|  <b>HYUNDAI</b>   NEW THINKING.<br>NEW POSSIBILITIES. | GROUP<br><b>CAMPAIGN</b>  | NUMBER<br><b>16-01-032</b>       |
|  | DATE<br><b>AUGUST 2016</b>  | MODEL(S)<br><b>SANTA FE (NC)</b> |
| <b>SUBJECT:</b>  | TCU UPDATE – SHIFT HESITATION AND SHOCK IMPROVEMENT<br>(SERVICE CAMPAIGN TJJ) |                                  |

**TCU ROM ID Table:**

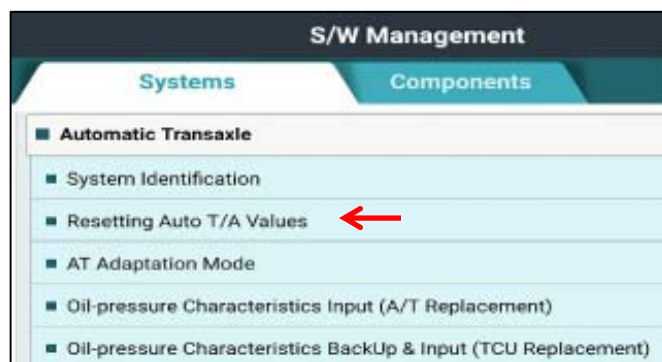
This bulletin provides information related to the TCU software update for certain 2017 Santa Fe vehicles that may experience a transmission hesitation or shift shock when accelerating at slow speeds.

| Model                 | TCM P/N                    | CAL ID  |                 |
|-----------------------|----------------------------|---|-----------------|
| 2017 Santa Fe<br>(NC) | 39110-3CDP0<br>39100-3CDP0 | TNC0G33N*****L0<br>TNC0G33N*****L1<br>TNC0G33N*****L2 | TNC0G33N*****L3 |
